**PLANNED UNIT DEVELOPMENT
& SUBDIVISION STAFF REPORT****Date: September 5, 2019**

DEVELOPMENT NAME Springhill Realty Subdivision

CONTEMPLATED USE Planned Unit Development Approval to amend a previously approved Administrative Planned Unit Development to allow shared access and parking between multiple lots, as well as a resubdivision of three existing lots of record into two lots.

SITE PLAN

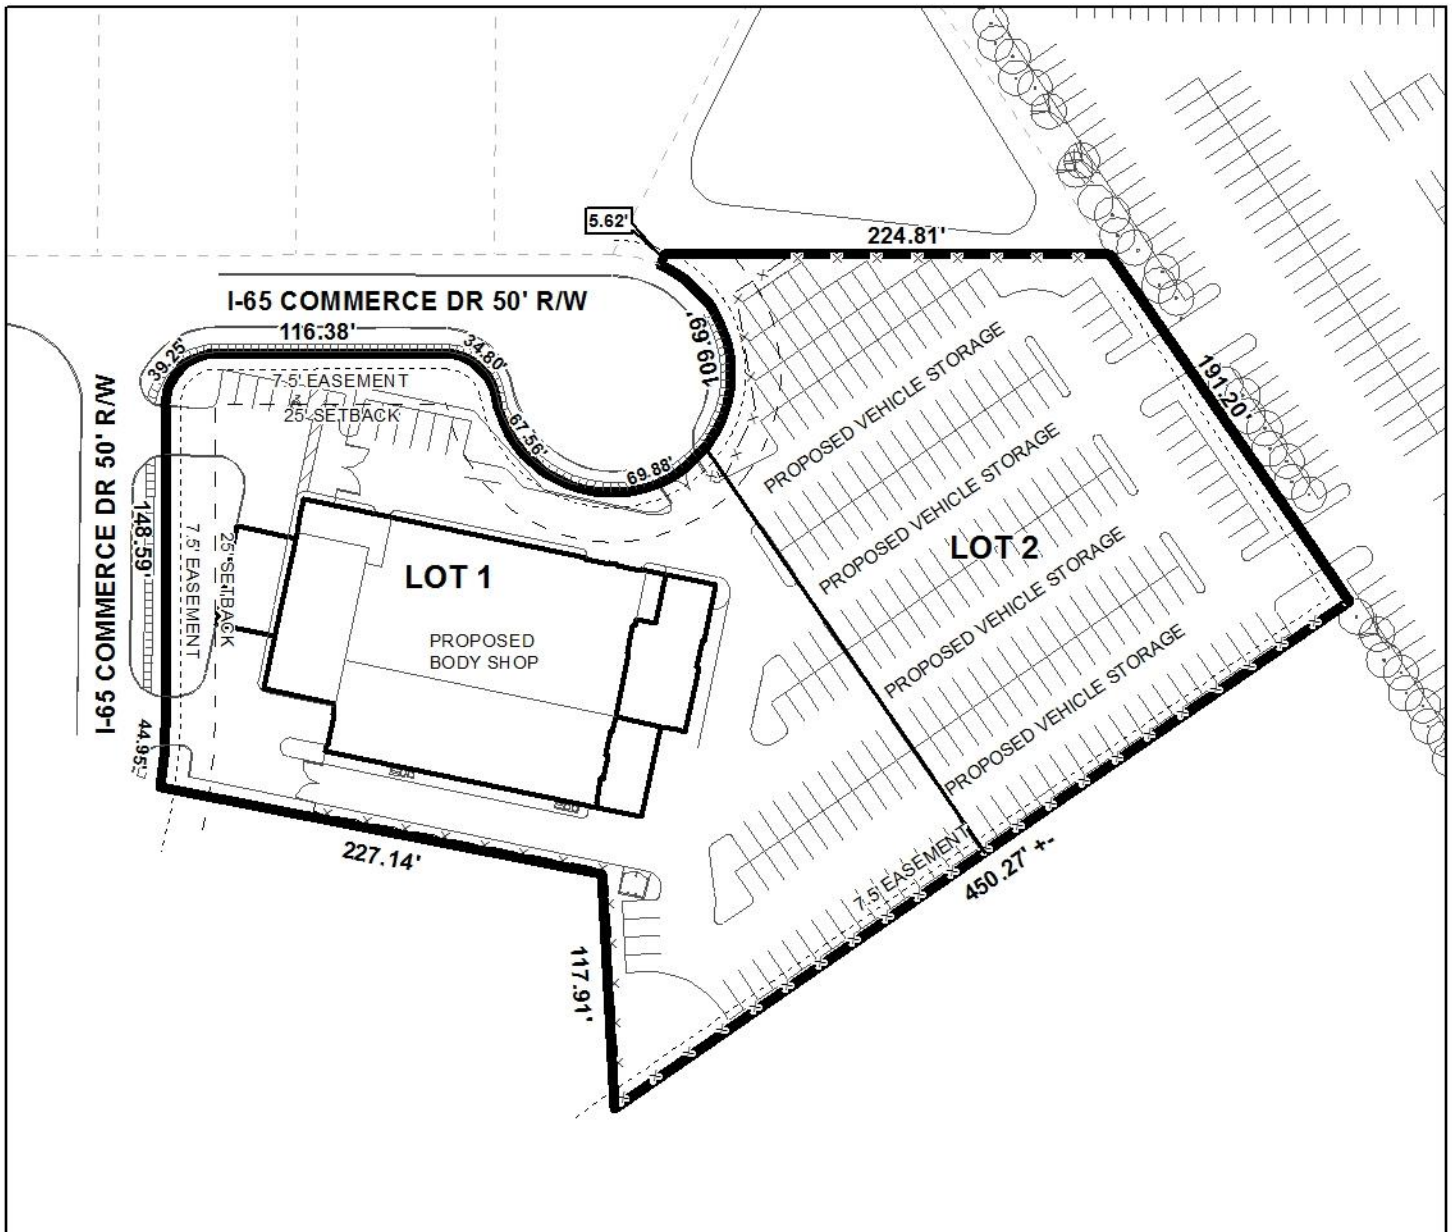
The proposed lots, as depicted, meets the minimum size and frontage requirements of the Subdivision Regulations and the lot area size is depicted on the plat in square feet and acres. The lot sizes should be retained in square feet and acres on the Final Plat, if approved. The PUD site plan does depict the lot sizes in square feet and acres; however, the site plan depicts the lots as Lot A and Lot B. The preliminary plat depicts the lots as Lot one and Lot two. The site plan needs to be revised to reflect the labeling on the preliminary plat.

According to the PUD site plan, the site fronts I-65 Commerce Drive and Commerce Court East, two minor streets with curb and gutter, with an adequate 50' right-of-way provided; therefore, no dedication is required. However, the subdivision plat should be revised to depict a 50' right-of-way width for I-65 Commerce Drive and Commerce Court East.

The site plan should be revised to depict the correct labeling of the streets as I-65 Commerce Drive and Commerce Court East.

The applicant proposes to construct a large asphalt paved parking lot (on Lot Two) that will be used for vehicular inventory storage; with 181 parking spaces designated specifically for the storage of the vehicles. The site plan also depicts the construction of 20,867 square foot building that will include a body shop, office, paint shop, storage, and work shop with additional parking on Lot One. The site plan is labeled as having 181 parking spaces for vehicular storage and 48 spaces for the body shop area. However, the actual total number of storage for vehicular parking is 198 spaces and 48 spaces for the body shop area. The site plan should be revised to reflect 48 parking spaces on Lot One and 198 parking spaces on Lot Two (246 parking spaces total). It should also be pointed out that there are 39 parking spaces that are depicted on Lot Two that are stacked and do not have proper access and maneuvering. Those 39 spaces can only be used for inventory and not for public or employee parking.

With regards to tree and landscaping requirements, although calculations have been provided, it appears that the total number of perimeter trees and frontage trees listed on the site plan is incorrect. Perimeter trees are not required for internal lot lines for Planned Unit Developments, and it appears that the interior lots line may have been included in the total number proposed to be planted. A total of 6 frontage trees are required along I-65 Commerce Drive, and a total of 14 frontage trees are required along Commerce Court East, all of which must be heritage trees. The tree and landscaping calculations should be revised on the site plan to reflect tree planting calculations for both perimeter and frontage trees only for the exterior property boundaries and to take in account any additional parking spaces that will be utilized for the body shop which would require more parking trees.

There are multiple drainage and utility easements located on the proposed lots. A note should be placed on the Final Plat and site plan stating no structures shall be constructed or placed in any easements. It should also be noted that there is an existing 15' private drainage easement that was located between the previously recorded Lot 15 and Lot A that is proposed to be relocated.

A dumpster is depicted on the site plan with a note stating the dumpster pad will be connected to sanitary sewer and enclosed per Section 64-4.D.9 of the Zoning Ordinance. There is also a note stating that parking lot lighting will comply with section 64-6.A.8 of the Zoning Ordinance on the site plan. The photometric note should be revised on the site plan to state parking lot lighting will have to comply with the requirements of Sections 64-4.A.2., 64-6.A.3.c., and 64-6.A.8. of the Zoning Ordinance. A photometric plan will be required at the time of submittal for land disturbance permits. All new and existing notes should be retained on future site plans.

- 1) revision of the site plan to label the lots as Lot One and Lot Two;
- 2) revision of the site plan to correct the labeling of the streets Commerce Court East and I-65 Commerce Drive;

- 3) revision of the site plan to reflect the total number of parking spaces (246 spaces);
- 4) placement of a note on the Final Plat stating no structures shall be placed in any easements;

- 8) retention of the a sidewalk along all street frontages;
- 9) revision of the site plan to reflect tree planting calculations for both perimeter and frontage trees only for the exterior property boundaries;

- 10) retention of all new and existing notes on the site plan;
- 11) placement of a note on the site plan stating that a photometric plan, in compliance with Sections 64-4.A.2., 64-6.A.3.c., and 64-6.A.8. of the Zoning Ordinance, will be required at the time of submittal for land disturbance permits;
